Certificate of Appropriateness

Property	3102 W. MC KINLEY BL. Cold Spring Park Historic District
Description of work	Remove about nine feet of the north foundation wall and rebuild it with new concrete footing and concrete block wall that will be veneered on the exterior above grade with pressed brick that are re-claimed from the existing wall above grade. Remove the existing rear concrete stoop and sidewalk to allow for excavation. Stoop is not original to the house and will be replaced with a deck/porch that will be reviewed in a separate certificate of appropriateness application to be submitted at a later date.
Date issued	1/27/2014 PTS ID 92444 COA, rebuild 9 foot section of north foundation wall

Interior condition of rear foundation wall that will be partially rebuilt using a new concrete footing, block walls and exterior veneer above grade of brick that are re-claimed from the existing foundation.

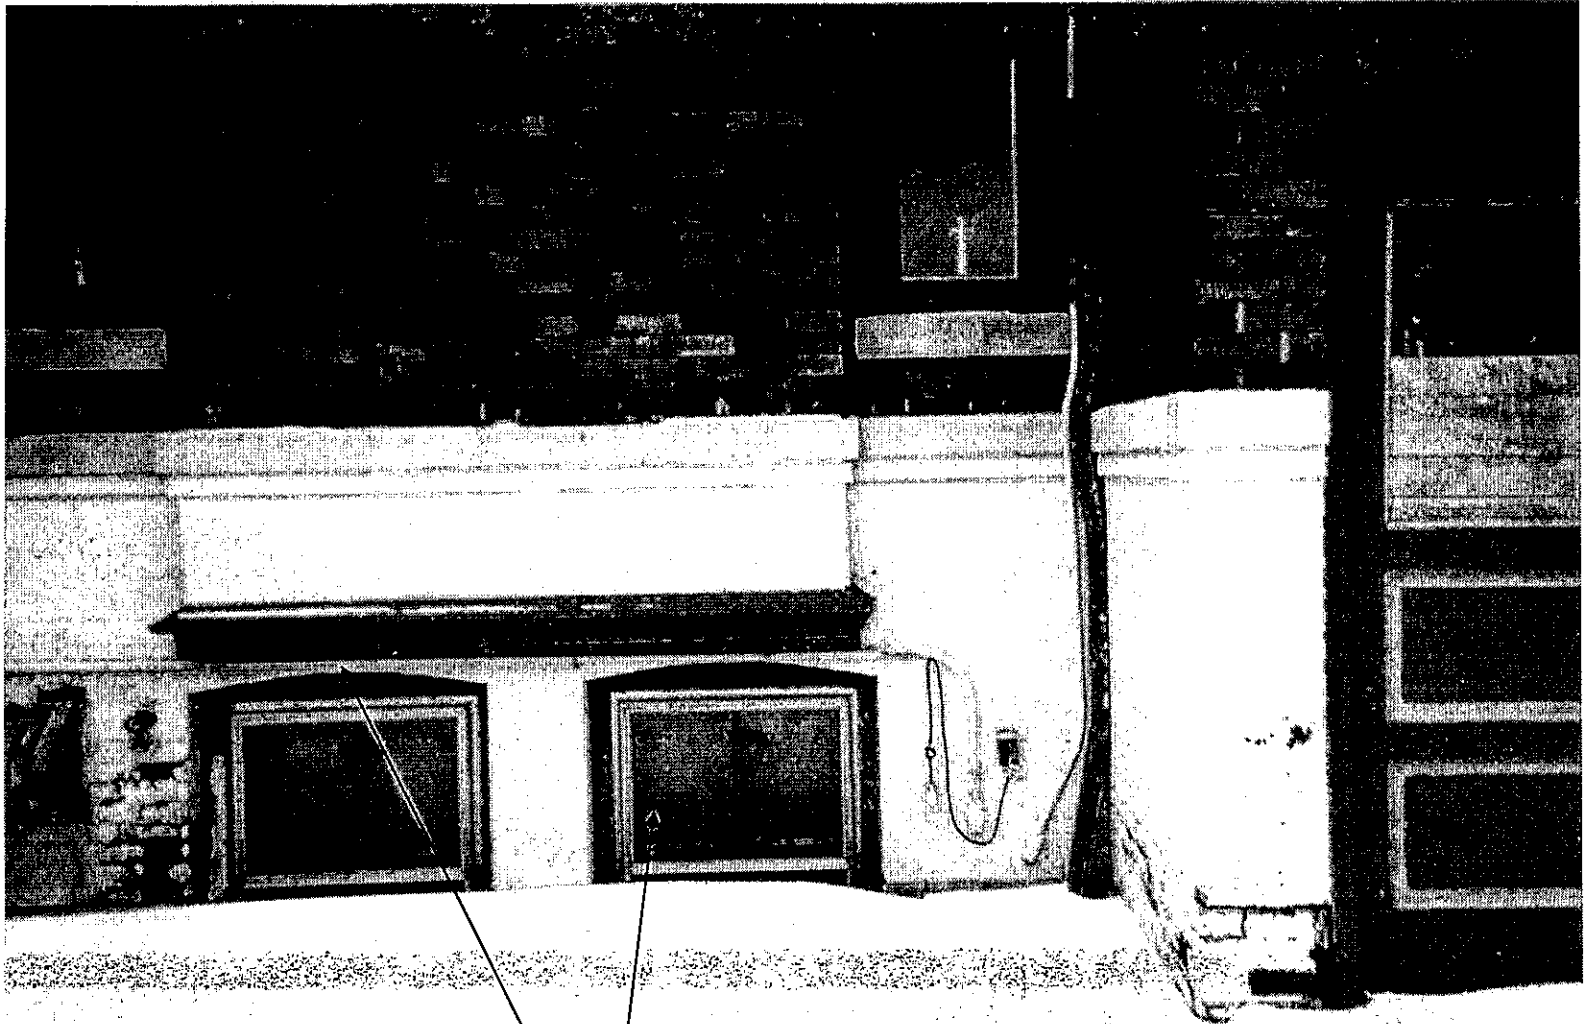
Exterior brick to be carefully salvaged for re-use whenever they are removed

Remove concrete steps. Owner will submit separate COA application at a later date for a new rear porch/deck.

If windows are removed, they must be salvaged and re-installed or new wood windows can be installed but they must match exactly the existing window including the segmental-arched window tops.
